CONCLUSIONS AND SUGGESTIONS AFTER EEP-VCF STAFF VISIT AT THE POZNAN ZOO

The Bearded Vulture new aviary:

Picture 2: Two wooden caves are installed in opposite pillar corners. Both nests have a fixed iron leader.

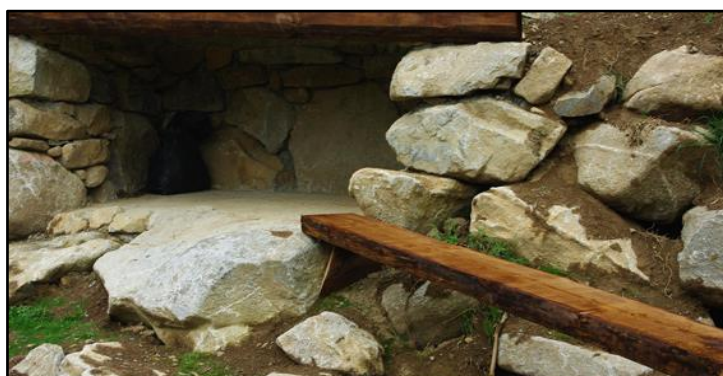
- Bearded Vultures as cliff breeders use small caves in the wild (90-120cm height), and well protected from bad climatology. Is well known that Bearded Vultures by wet nest normally abandon the clutch. It will be necessary to **enlarge (min. 1m) the wooden roof of both caves** for assuring that the nests will be always dry.

- Bearded Vultures as cliff breeders, the perches need to be adapted to suit the anatomy of their feet. For assuring to maintain its balance on it is recommended to install flat perches, around 20cm wide, 4-5cm thick and also need to be rigid enough to prevent them from bending during copulation on the perch. We recommend **to replace the branches -which are installed as perches- by wooden planks.**

Furthermore Bearded Vultures are soaring birds of prey and it is difficult for them, especially for females and older birds, to access perches/nest-platform through flapping flight. For assuring that the birds can climb without problems up to the nest by transporting material or food we suggest to **install the wooden planks in different altitudes.**
